Planning Commission Staff Report

Project Type: Site Development Section Plan

Meeting Date: June 25, 2012

Description: Spirit Valley Business Park, Adjusted Lot 10: A Site Development

TRASH ENCLOSURE DETAIL

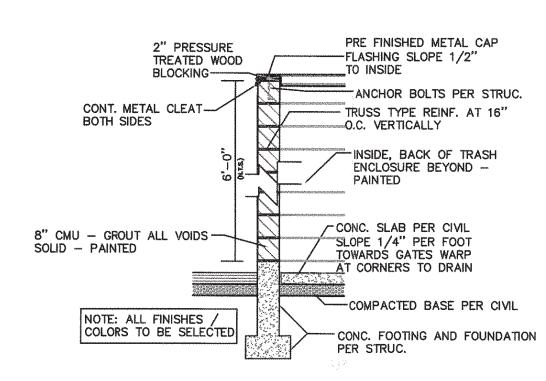
3. The trash enclosure is to be consistent with materials of the building.

As presented to the Architectural Review Board, the proposed plan did not include a separate trash enclosure, a required element for the site. While the enclosure was not shown, the Board did make the specific recommendation that the future enclosure be a material consistent with the building (tilt-up concrete panel or an architectural block painted to match the building).

Section 11.d. states: "Integrate the design of fencing, sound walls, carports, trash enclosures, rooftop screening, and similar site elements into the building design and construct with similar materials," and Section 12. states: "Screen trash enclosures and construct with materials consistent to the building."

The applicant has included a separate enclosure for trash constructed of materials consistent with ARB's recommendation. As shown, the proposal complies with the Architectural Review Standards.

RAIN GARDEN DETAIL

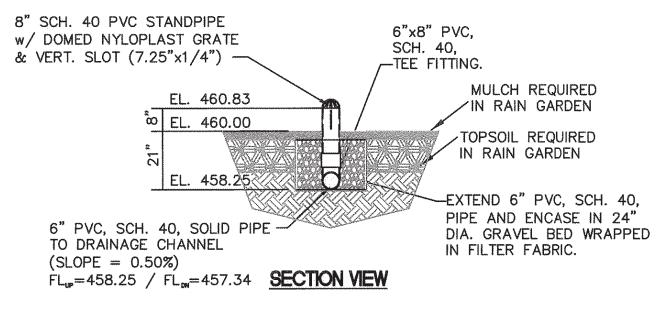
4. Clarification that the rain garden will be installed on site.

The rain garden is now shown on the Site Development Section Plan.
